## SUNDRY NOTICES AND REPORTS ON WELLS

BP America Production Company

NASSER FEDERAL 1

30.015-27865

**NASSER FEDERAL # 1**  
Indian Loafer Draw

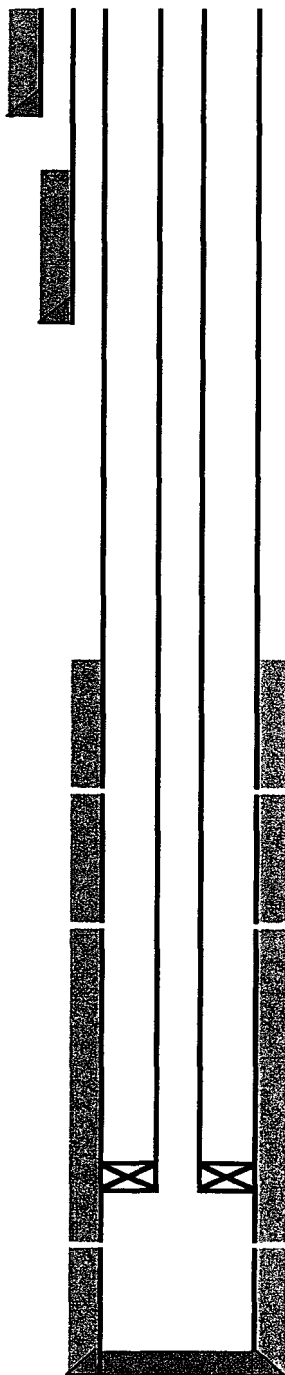
SCOPE OF WORK: PULL TUBING &amp; REPLACE BAD JT. GIH OE.

MIRUPU. BLEED DOWN TBG &amp; CSG PRESS.

PUMP SUFFICIENT 2% KCL TO PLACE WELL ON VAC.

NDWH. NUBOP. RLK PKR &amp; POH W/TBG. STRAP OUT OF HOLE. LD BAD JTS.

GIH W/2-3/8" SN &amp; TBG. LAND SN @ 7860+/- . PMP SUFFICIENT 2% KCL TO PLACE WELL ON VAC.

NDBOP &amp; NUWH. SWAB AS NECESSARY TO KICK WELL OFF AND TURN TO PRODUCTION

05.01.05: WELL HAD 300 PSI ON TBG &amp; CSG WHEN STARTED. KILLED WELL W/150 BBL 2% KCL WIR. WELL

WILL NOT CIRC. POH W/218 JTS 2-3/8" TBG &amp; 5 PMP JTS, APPROX 6780' OF TBG. FOUND PIPE PARTED.

JOINT # 181 HAD HOLES AND FROM JT 180 DOWN WAS SEVERELY PITTED & CORRODED. RIH W/2500' OF 2-3/8" YELLOW  
BAND TBG AND SHUT DOWN FOR ENRG EVALUATION.

APPROVED FOR 2 MONTH PERIOD

ENDING 7/5/05
